**Review of the
U.S. Department of Energy Responses to the
U.S. Nuclear Regulatory Commission
Requests for Additional Information on the West
Valley Demonstration Project Phase 1
Decommissioning Plan**

Prepared for
New York State Energy Research and Development Authority
West Valley, New York
December 14, 2009

Prepared by the
Independent Expert Review Team

Figure 1. Schematic for Exposure Scenarios Initiated by a Sub-Surface Source

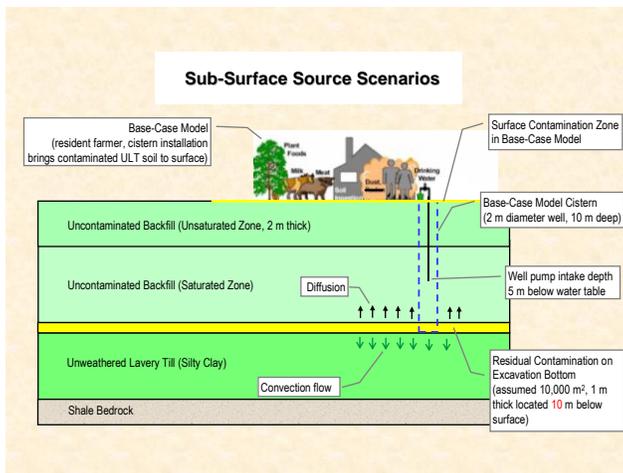
It is the understanding of this reviewer, based on the above, that DOE's response to RAI 5C6 relies on groundwater modeling which considers potential release of radionuclides from the bottom of a remediated excavation by diffusion. As noted in the second paragraph of my original comments on DOE Group 2 responses below, I consider such modeling inadequate. Instead, I expect contaminants from the bottom of each excavation to be drawn toward a pumping well completed within the backfill of the excavation not by a slow process of diffusion but much more rapidly by advection. Ignoring advection would underestimate the rate at which contaminants from the bottom of an excavation reach the well, thereby overestimating dilution and the derived DCGLs.

That such advection is disregarded is made clear by the recently submitted West Valley EIS/DPlan Calculation Package, Estimates of Human Health Impacts Due to a Sub-surface Source in the Vicinity of the Excavation at WMA1. As illustrated without ambiguity in Figure 1 of this package (reproduced below), (a) contaminants are taken to be released from the bottom of the excavation into the saturated zone of the backfill purely by diffusion, and (b) advective flow in Unweathered Lavery Till beneath the backfill is taken to continue being directed downward. In reality, a well pumping water from the saturated part of the backfill (pictured in Figure 1)

would cause groundwater flow, and hence advective transport, in the underlying shallow ULT to reverse course upward, through the contaminated bottom of the excavation (yellow in Figure 1), into the overlying (originally) uncontaminated saturated backfill, followed by lateral flow and contaminant advection toward the well.

The conceptual framework underlying the DOE revised calculations of contaminant transport from the contaminated bottom of a remediated excavation, through the originally uncontaminated saturated backfill, toward a well pumping water from the latter is fundamentally flawed and not conservative.

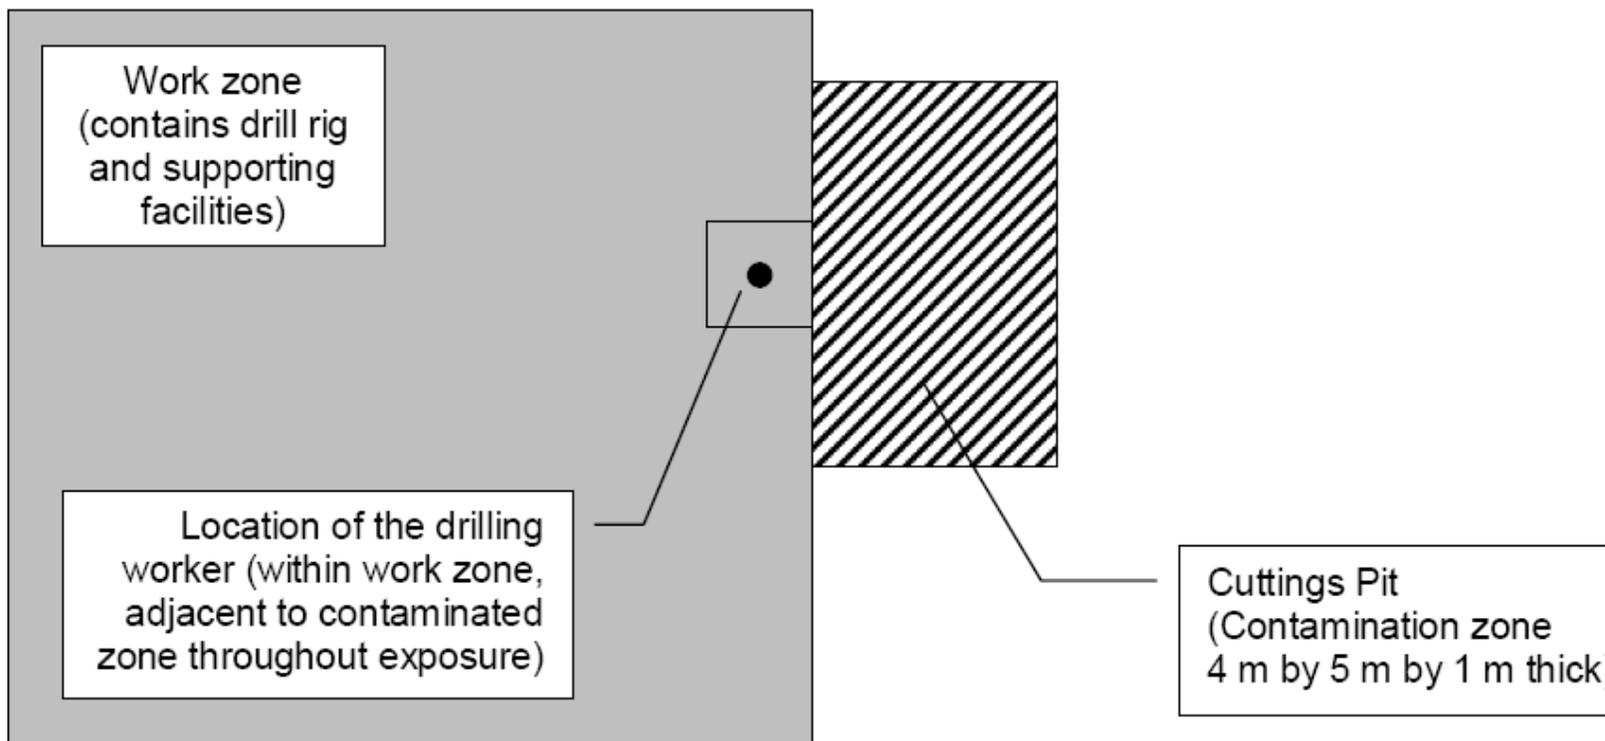
The RAI asked for a comparison of DCGLs for drilling a natural gas well with those for the cistern scenario. As the figure in the response shows (pasted below), the gas well was not drilled through contamination, so contaminated cuttings were not brought to the surface. It is not surprising that doses were low. The RESRAD files associated with this analysis were included in a zipped file. Since this analysis involves low doses from a borehole through uncontaminated soil, it is both uninteresting and not surprising.
